Planning Commission Meeting Agenda

1. Call To Order
2. Roll Call
3. Approval Of The Agenda
4. Approval Of The Minutes Of The Previous Meeting
5. Old Business
6. New Business
 - 6.I. Public Hearings
 - 6.I.i. (PUD1602) (Ordinance No. 2016-06) Jag Development, LLC, 2000 Chicago Dr., Is Requesting (Rezoning From LDR To PUD) Preliminary Planned Unit Development Approval And Final Development Approval For Condominiums, Along With Amenities, On A Parcel Of Land Described As P.P. # 70-14-14-100-015, Located At 1347 Baldwin, Georgetown Township, Ottawa County, Michigan.

RE: Baldwin Woods – Revised Preliminary PUD & Final Development Plan

ENTRANCE FEATURE CONCEPT
N.T.S.

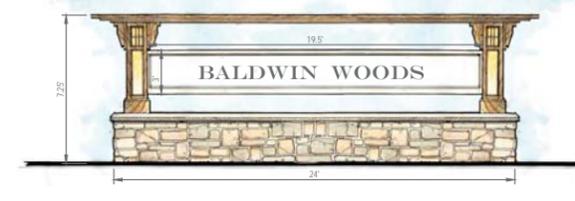
Comment: Please provide evidence that the sign coordinates with the architecture of the buildings.

Comment: Elevations were provided. Demonstrate how the proposed sign encompasses the same theme. Also, provide sign details, including dimensions from the centerline, height and square footage.

Response: **The entry feature signage will use design elements of the proposed condo buildings to create a cohesive appearance among all site structures. The entry feature signage design is to use a common color scheme, material usage as well as architecture style as the condos. For instance, the wood portions of the sign are to be treated in the same manner as the wood elements of the condos. The same stone used on the condo walls will be used to construct the base of the sign. Architectural features such as the corbels in the peaks of the condos were repeated on the posts of the entrance sign to reinforce the unified character of all proposed structure.**

Response: **Sign details, including dimensions, are now depicted in the plan set.**

BALDWIN WOODS
PRELIMINARY PUD GRADING & UTILITIES PLAN
1347 Baldwin Street, Jenison, Michigan 49428
PART OF SECTION 14, T6N, R13W,
GEORGETOWN TOWNSHIP, OTTAWA COUNTY, MICHIGAN

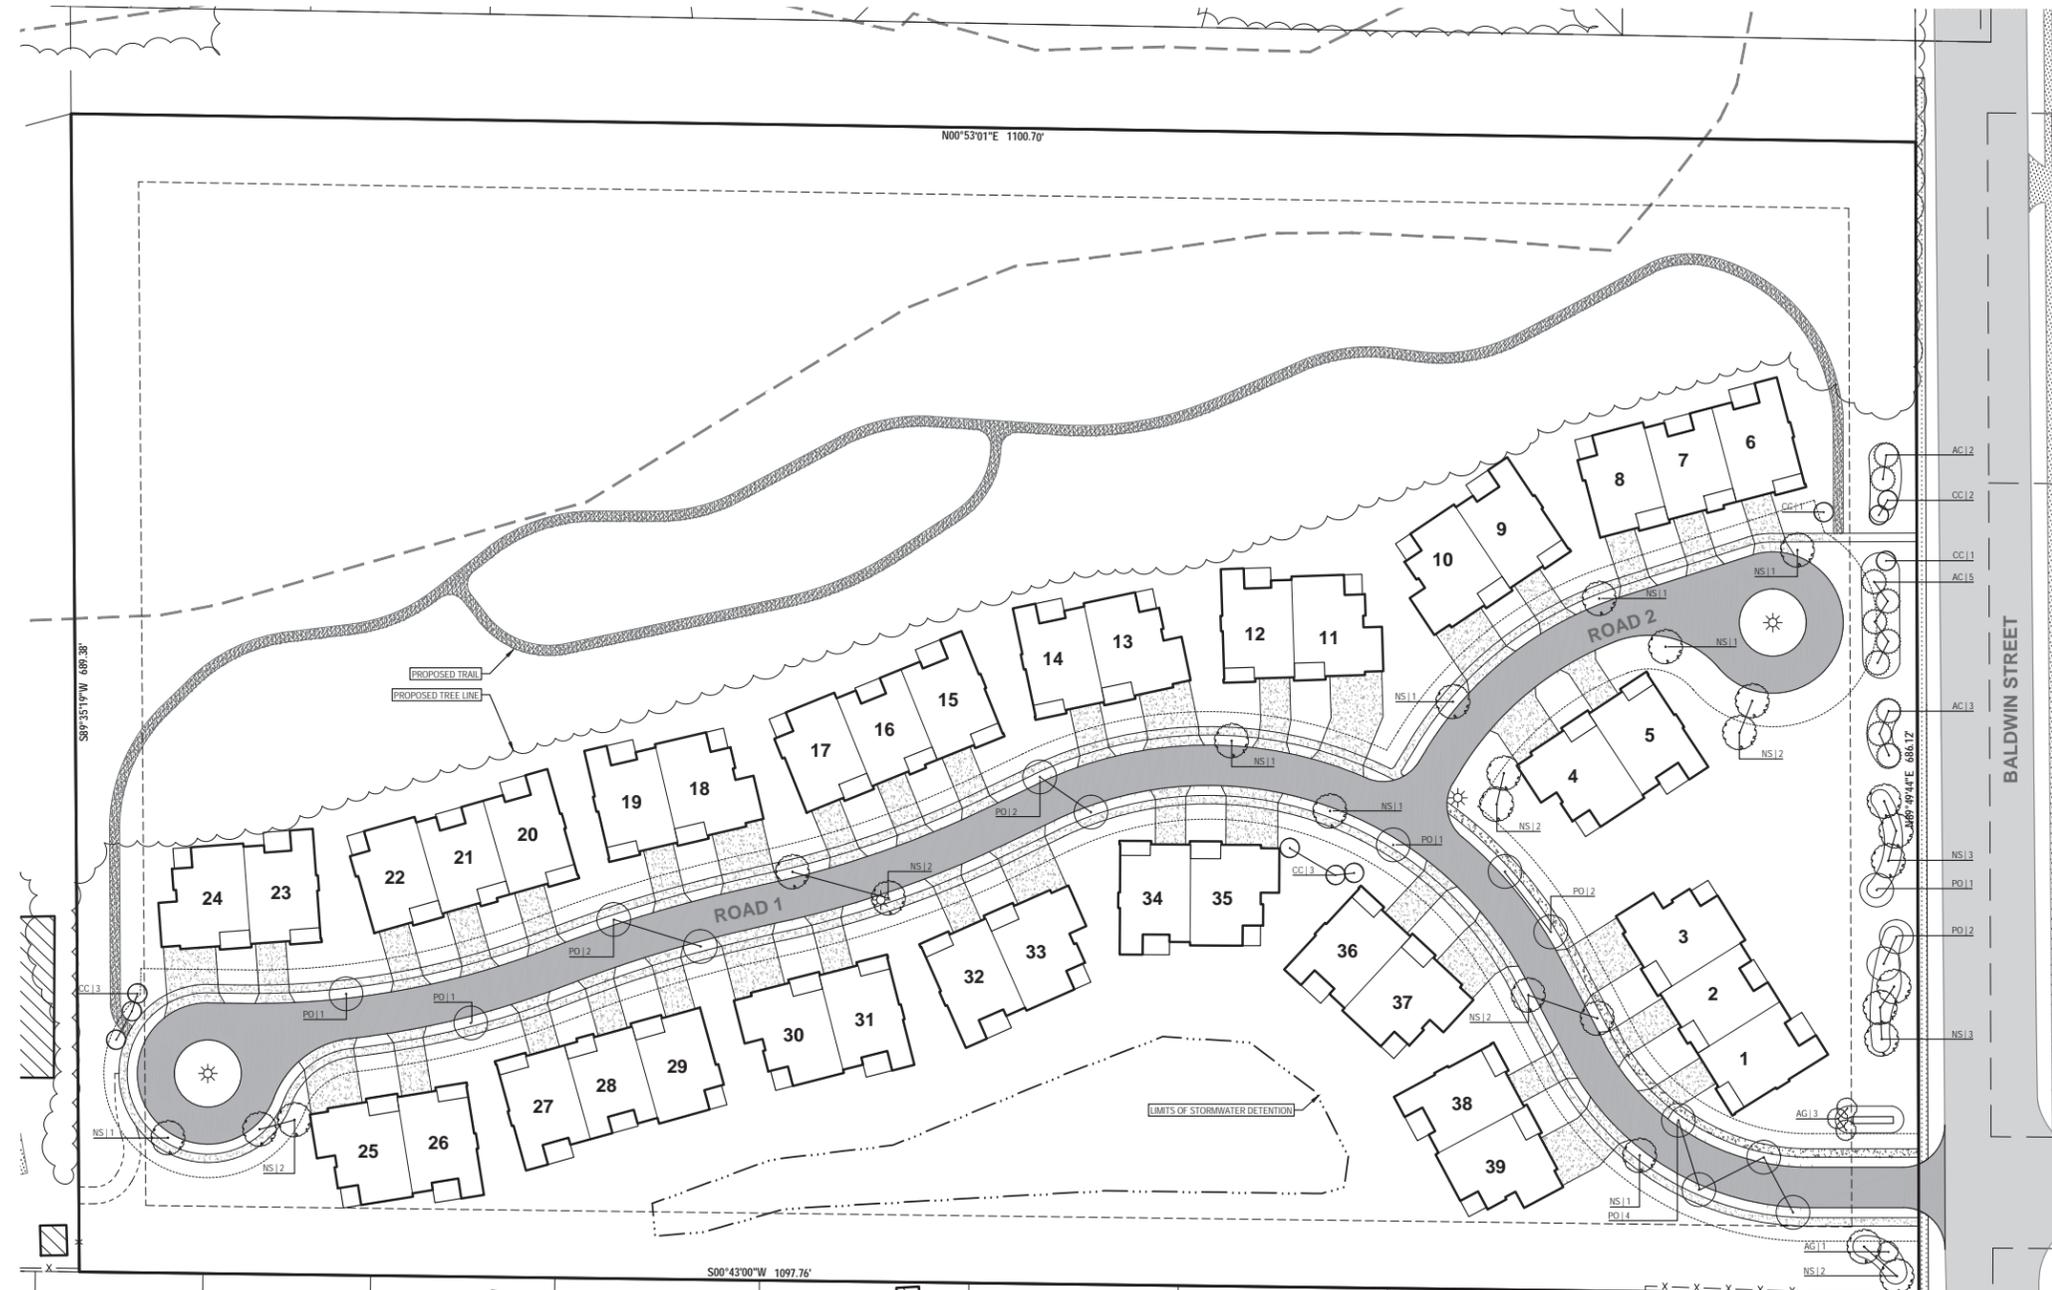
Comment: Interior sidewalks and pedestrian paths are proposed, along with sidewalk adjacent to Baldwin St. Indicate either on the plan or on a separate document that the hill to the sidewalk along Baldwin will be graded and the retaining wall removed.

Response: **See C-102, retaining wall to be removed and area to be regraded to eliminate the need for a retaining wall.**

BALDWIN WOODS
OPEN SPACE PLAN

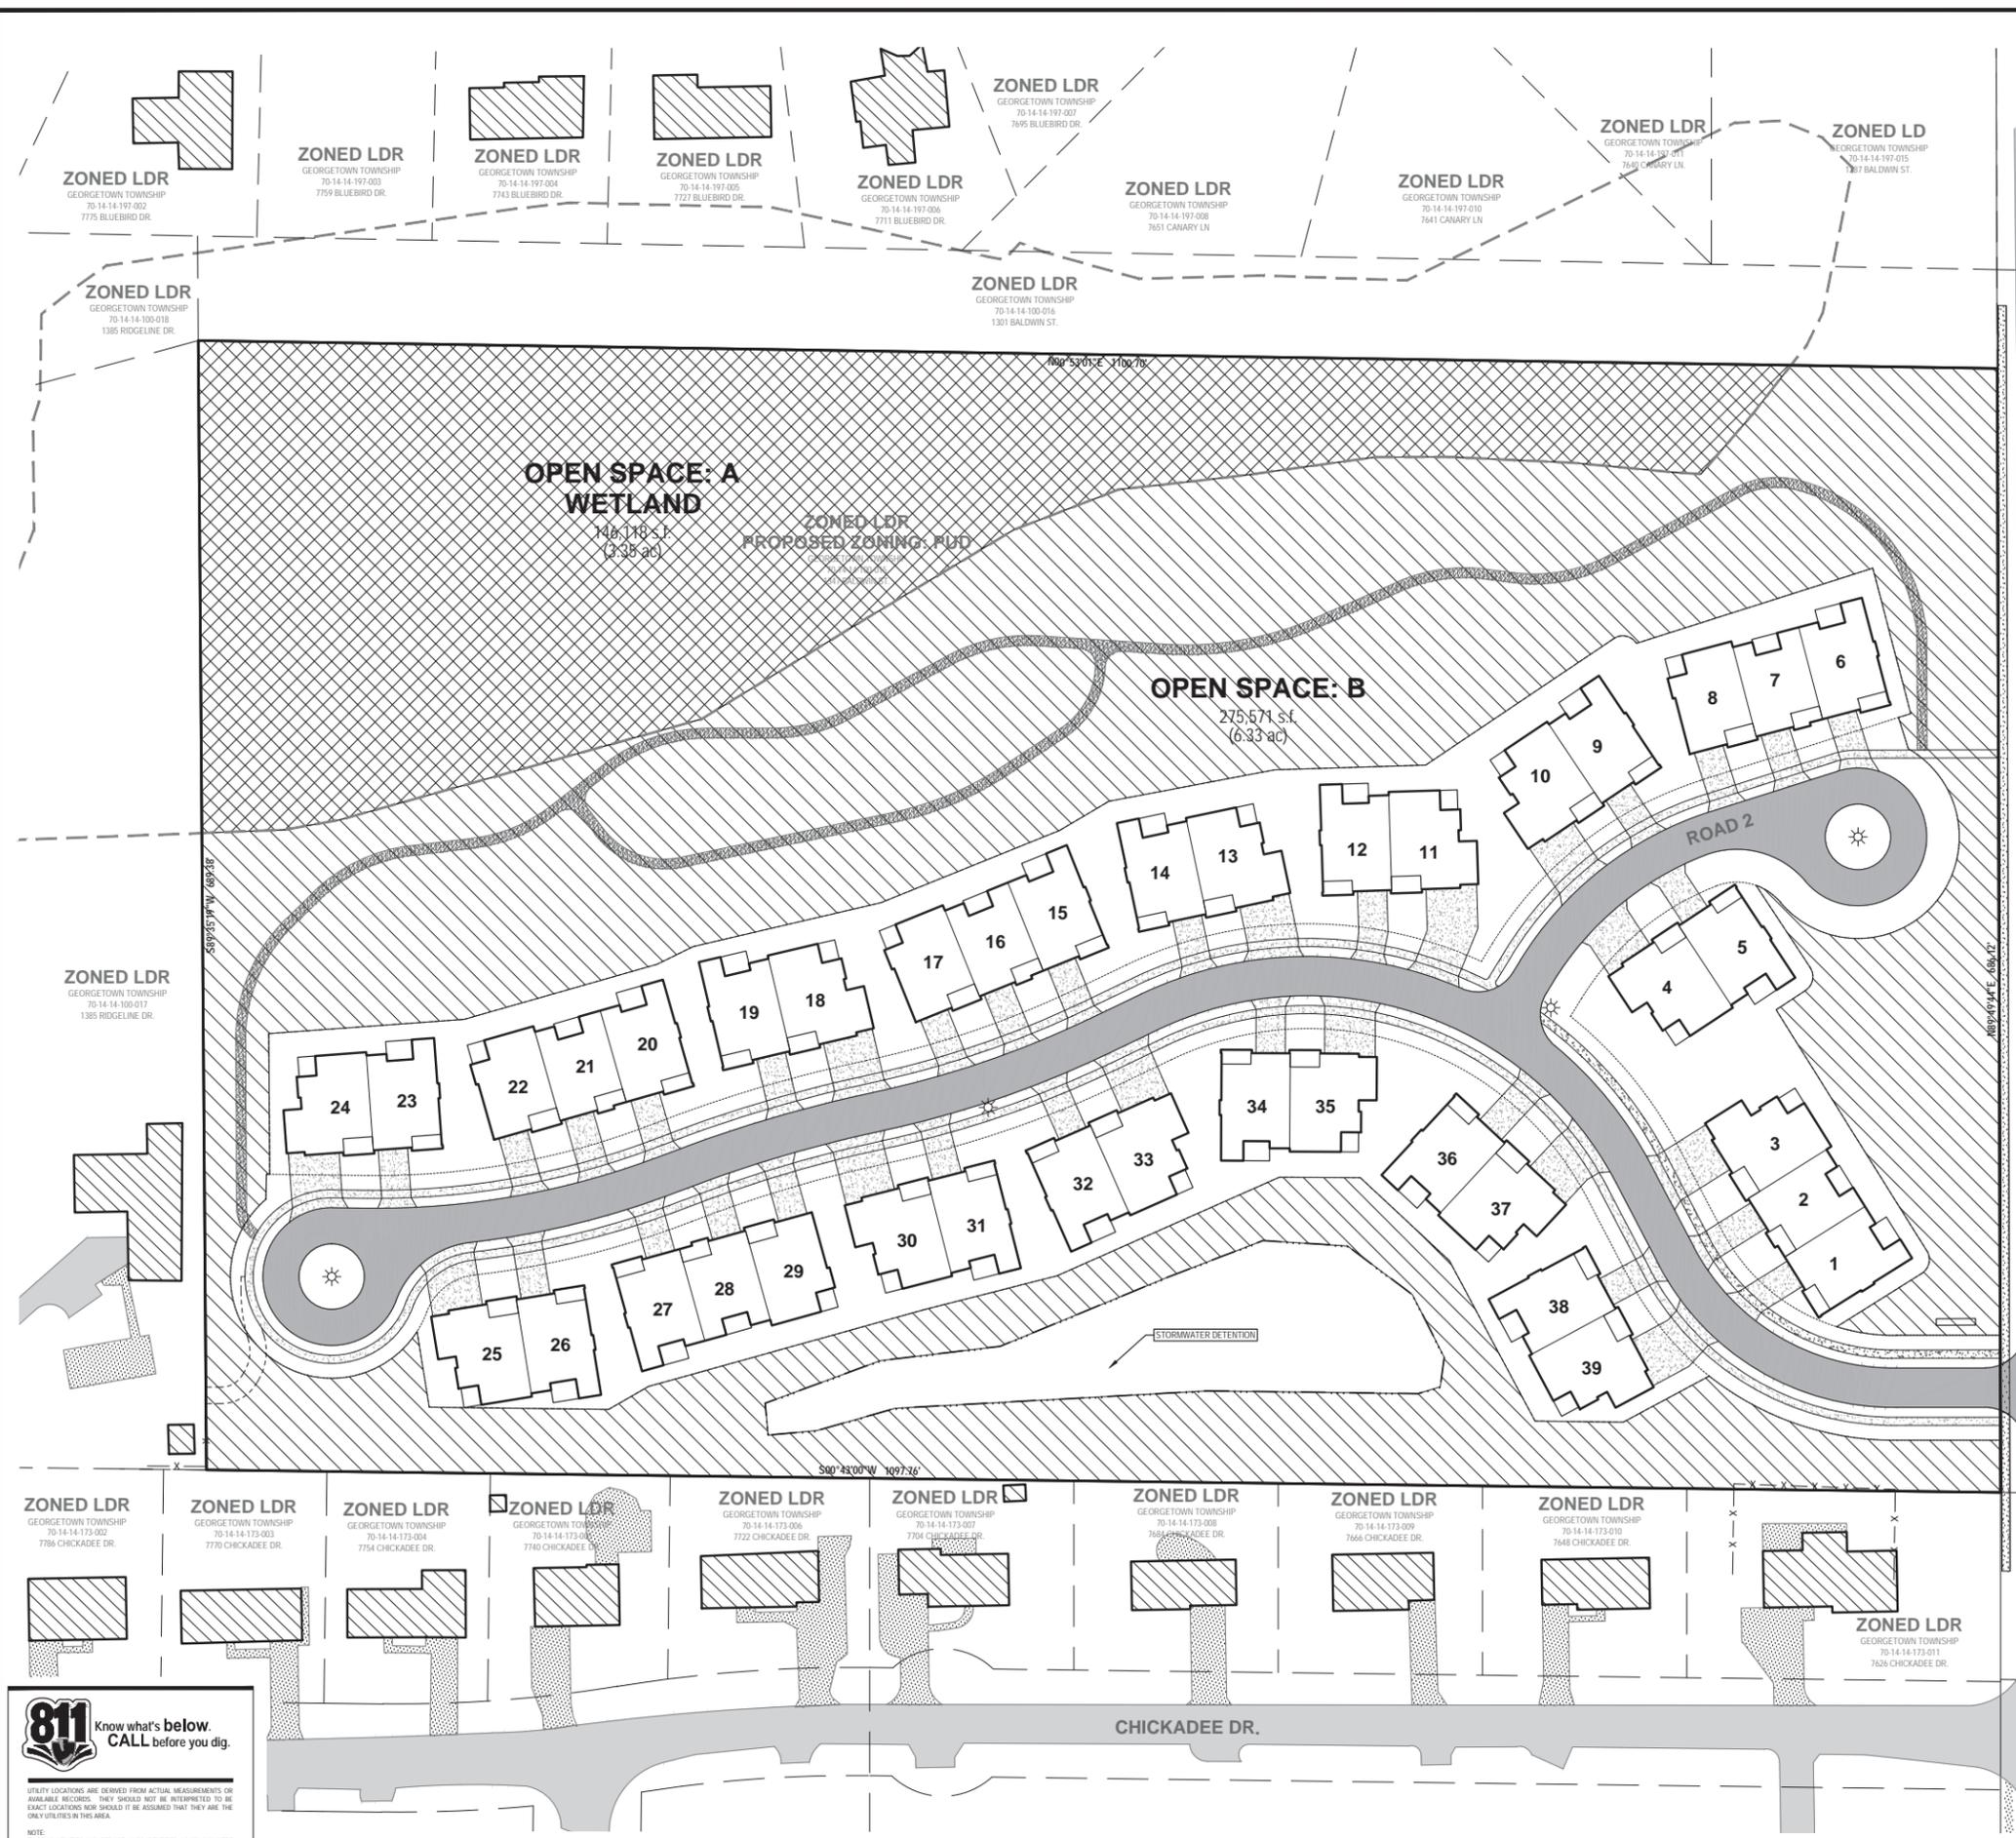
Comment: The Plan states that 36.46% of the property is open space, which exceeds the minimum amount required. Is the developer planning to deed part of the wetland to the Township in order to preserve the open space in perpetuity?

Response: **A portion of the eastern property will be dedicated to the township. This area is now depicted in the plan set.**
